Re: Second Submission Review – Green Valley Ranch East Site Plan No. 15 - Site Plan and Plat

Application Number: **DA-1662-26**

Case Number(s): 2022-4014-00; 2022-3019-00

GREEN VALLEY RANCH EAST SITE PLAN #15

SHEET 20 OF 36

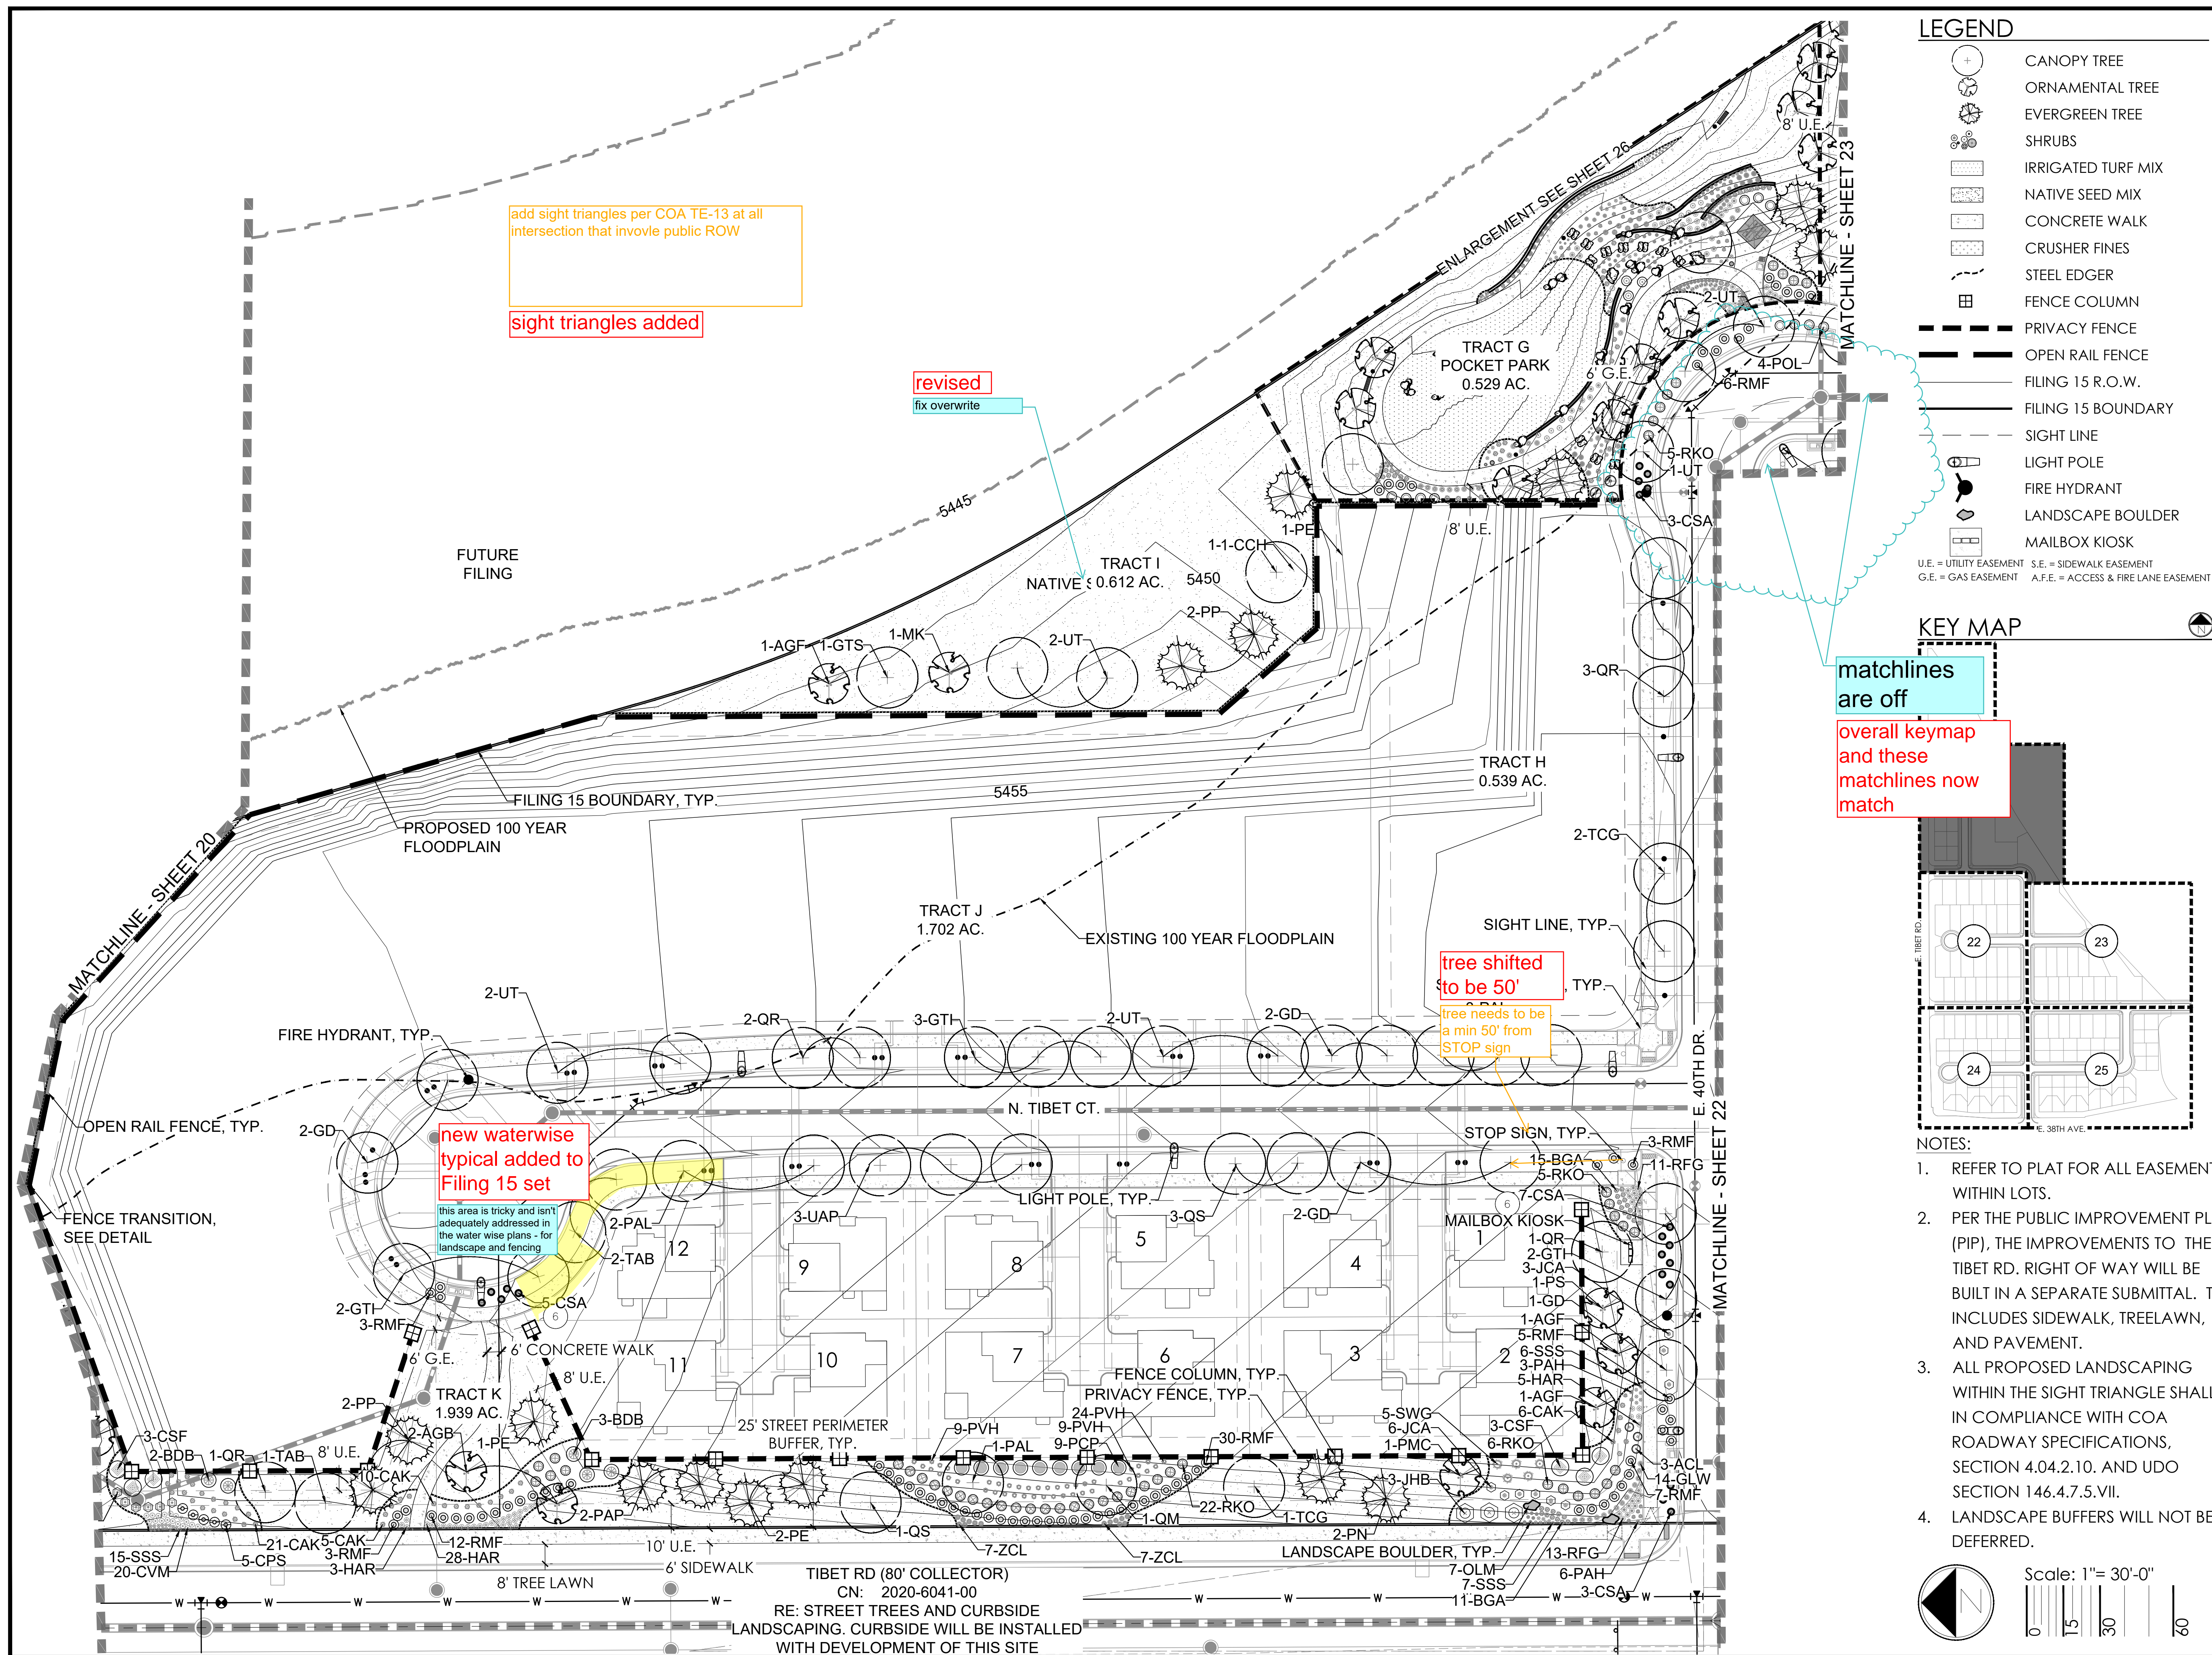
7F. Landscape Comments: add sight triangles per COA TE-13 at all intersection that involve public ROW. Tree needs to be a min 50' from STOP sign. Add sight triangles per COA TE-13. **RESPONSE: Sight lines added and trees revised**

add sight triangles per COA TE-13 at all intersection that invovle public ROW

SHEET 23 OF 36

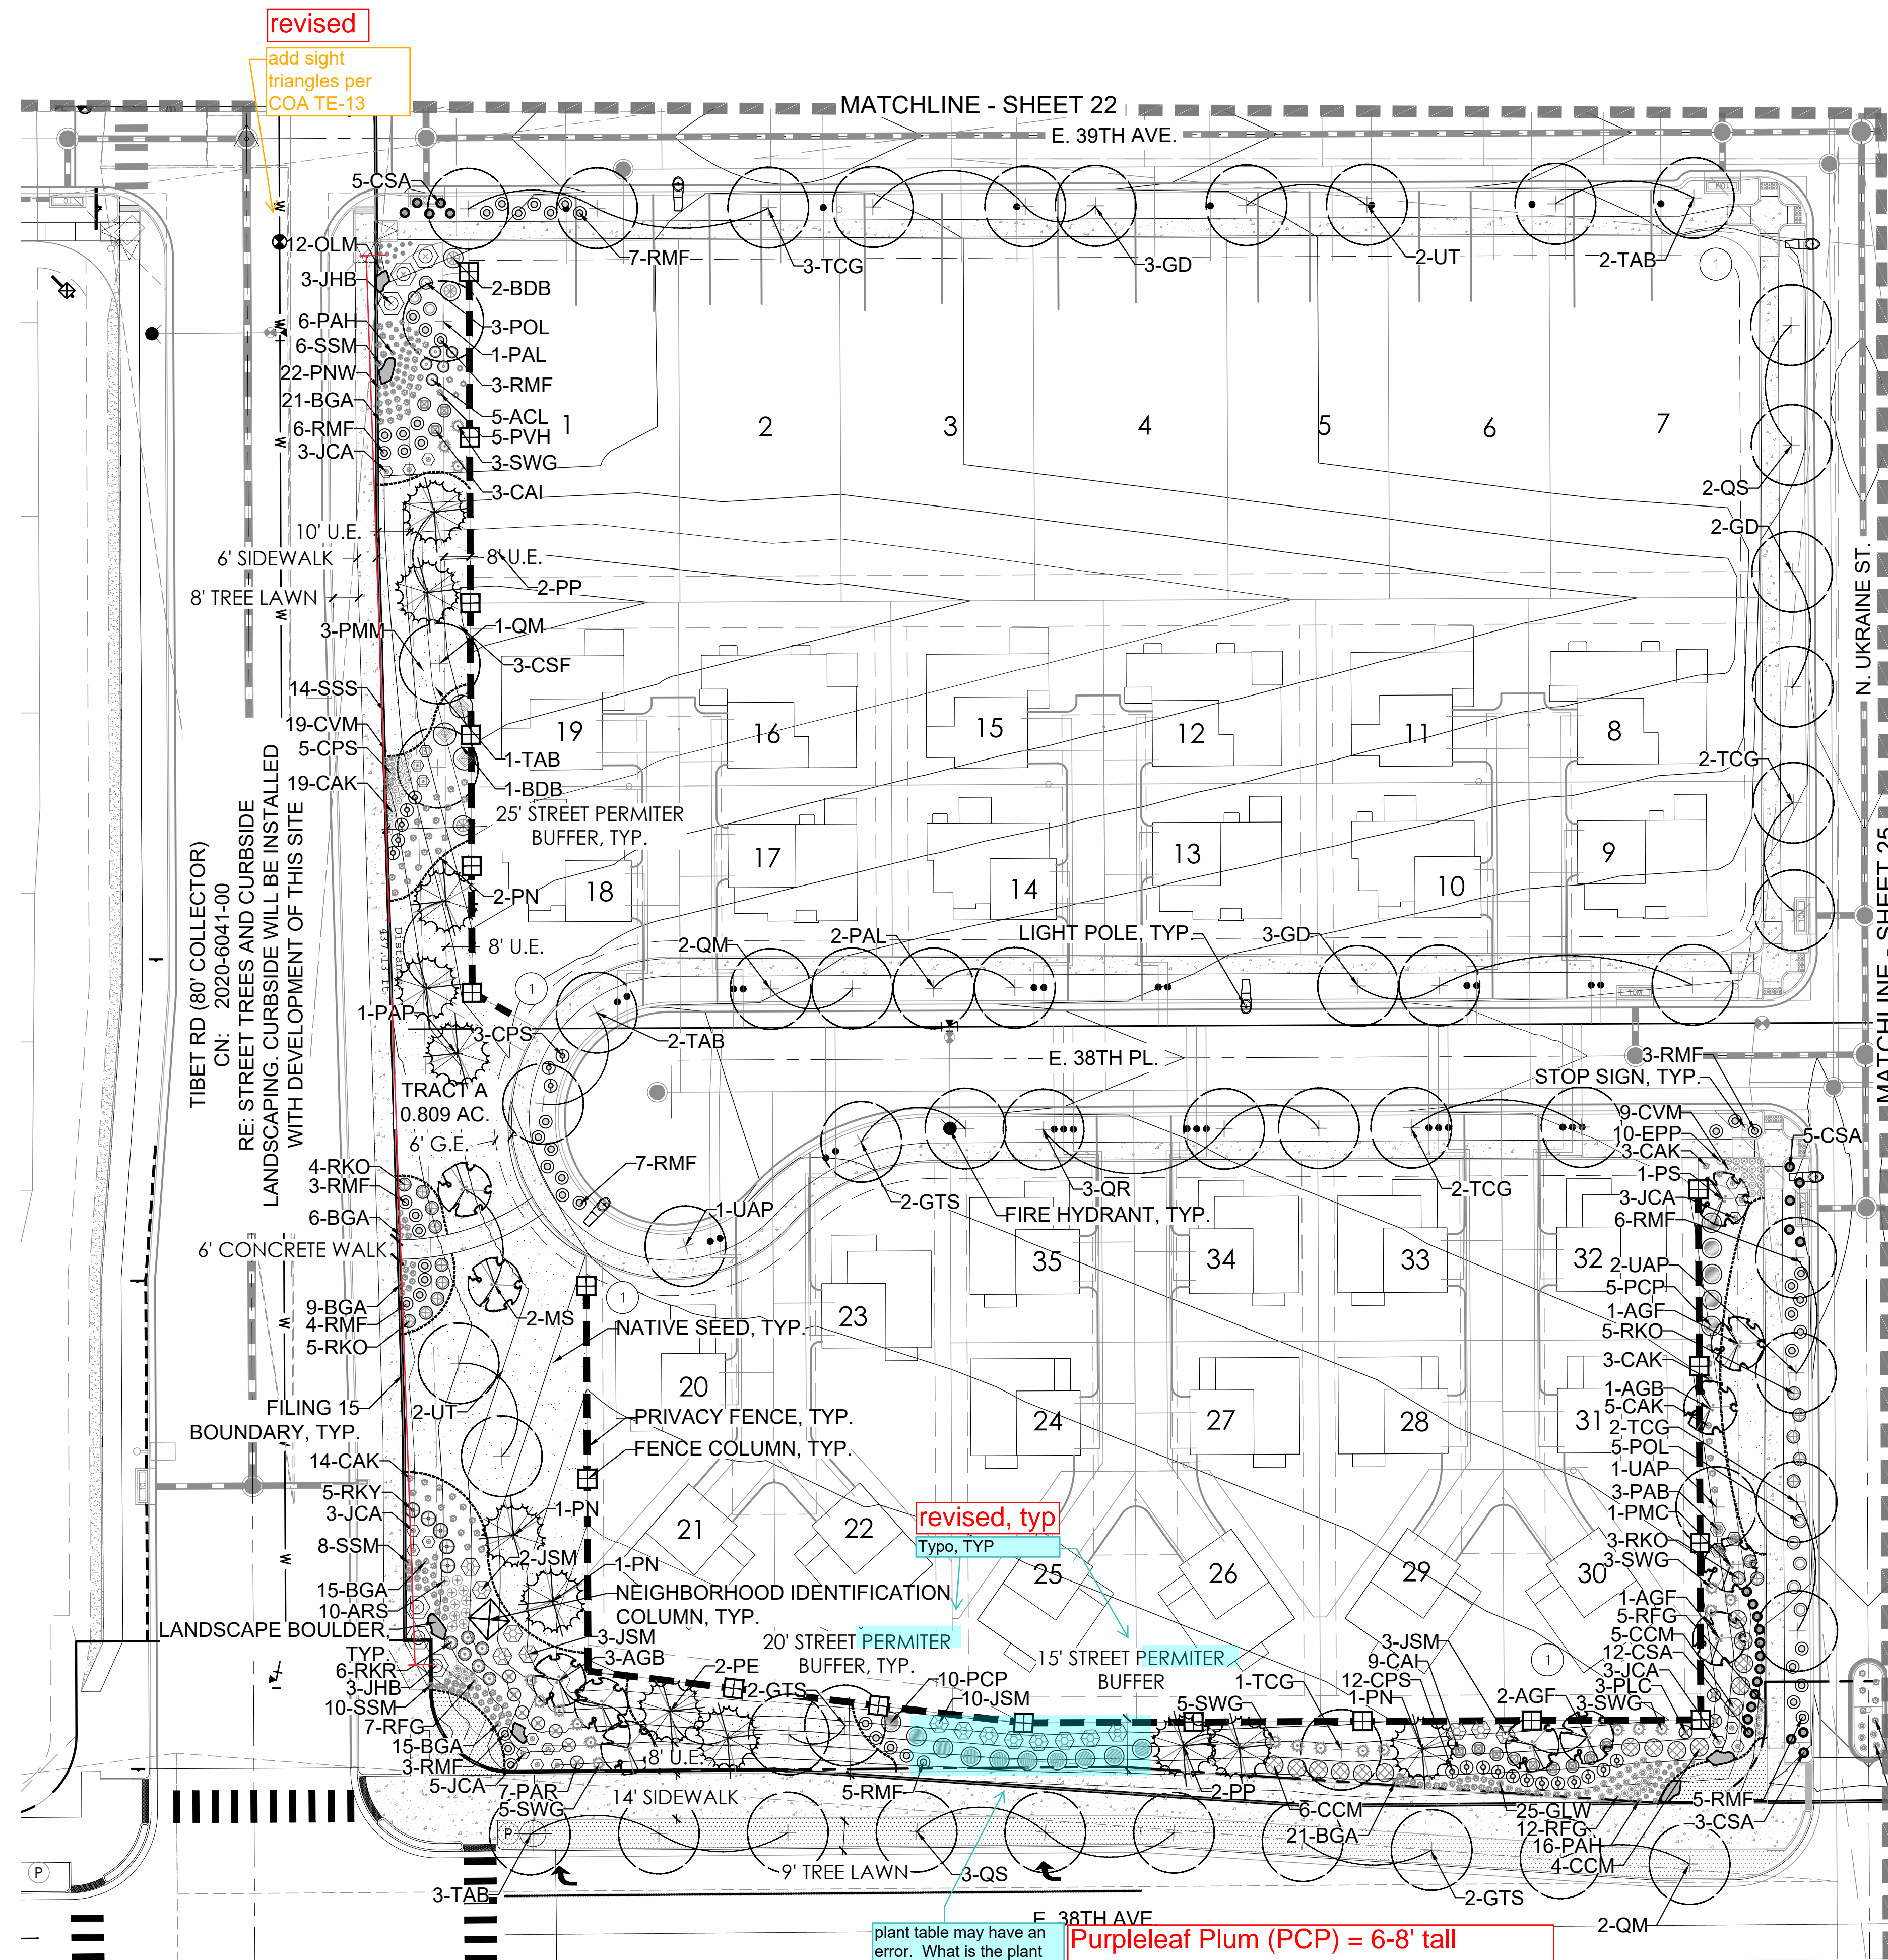
- 4G. Provide more tall/vertical landscape in 38th Avenue buffer where the width is less than 20-feet. **RESPONSE: Additional ornamentals added.**
- 4H. Add footnote numbers to the Open Space Table and link them to the line items that are applicable. For example, the note regarding the exclusion of floodplain should be specifically linked to Tract K. **RESPONSE: Footnotes added to table.**

plant table may have an error. What is the plant material that will be tall enough to contribute to the buffer?

Purpleleaf Plum (PCP) = 6-8' tall
Moonglow Juniper (JSM) = 12'-15' tall
Plants table had error. these plants
should supply sufficient screening.

6 LANDSCAPE RETAINING / SEAT WALL
SCALE: NTS

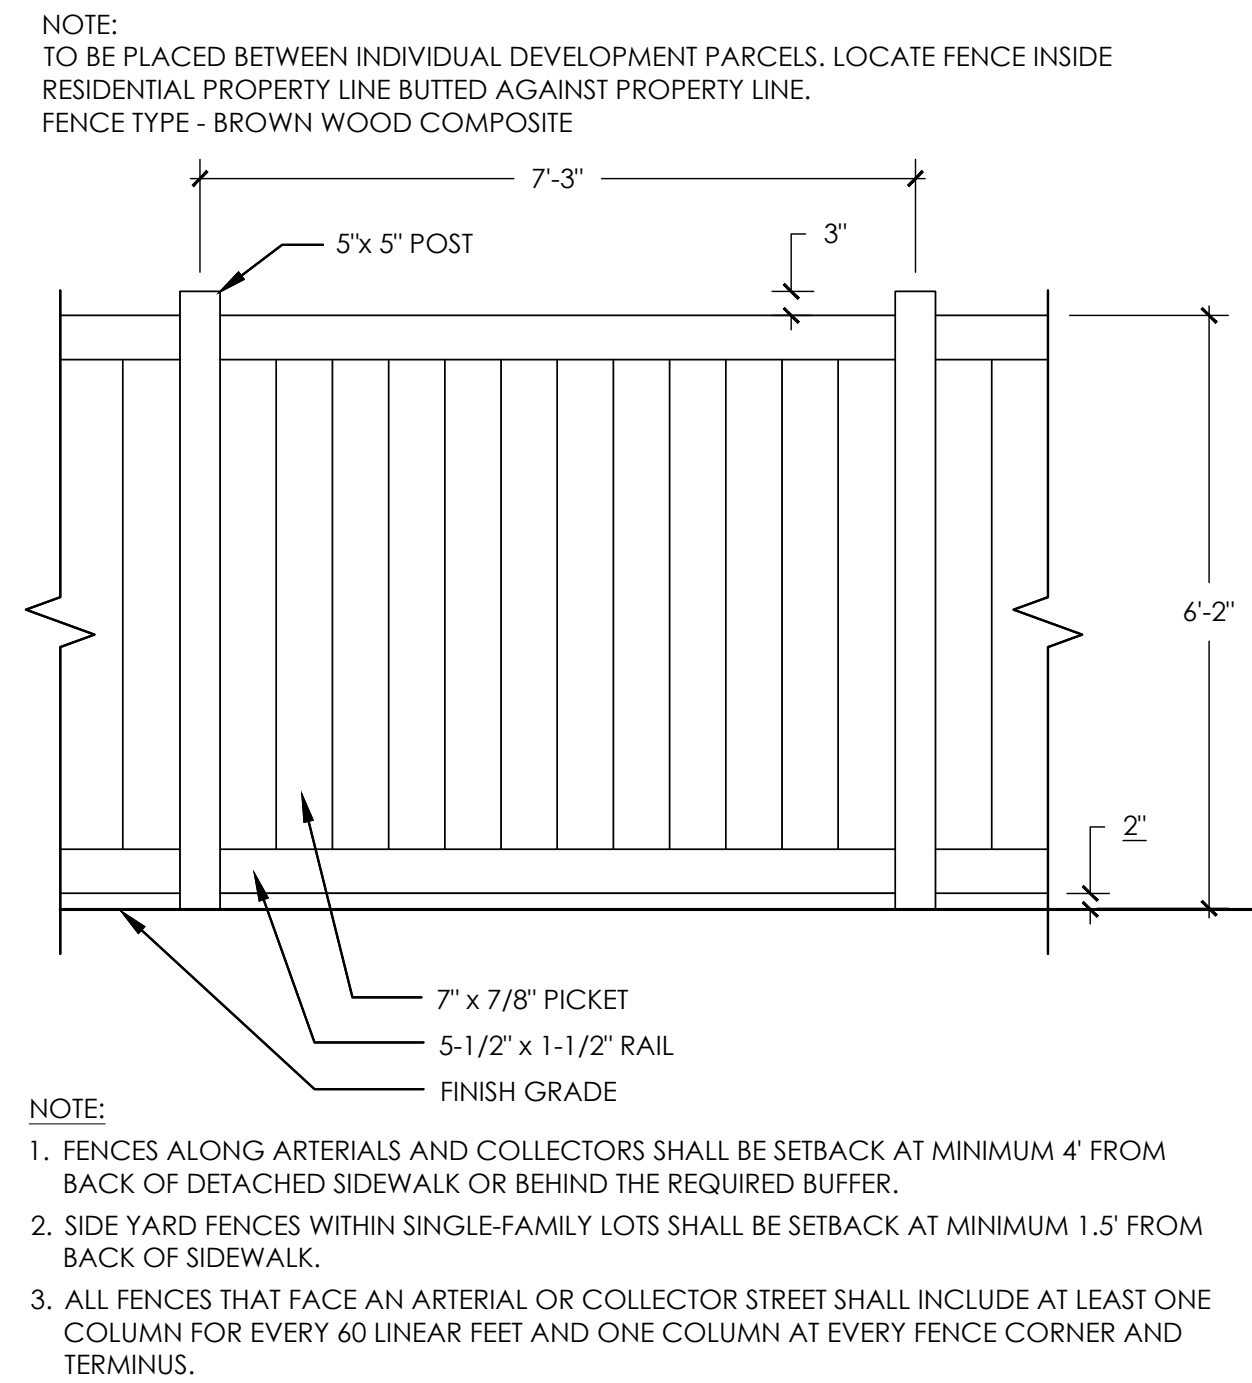
- 4K. Add the minimum distance between retaining wall to Detail 6 on Sheet 28. Code required a minimum of 36".
RESPONSE: Detail revised.
- 4L. The landscape notes reference a landscape bollard. Provide a detail. **RESPONSE: Detail for security lighting moved to same sheet as light poles.**
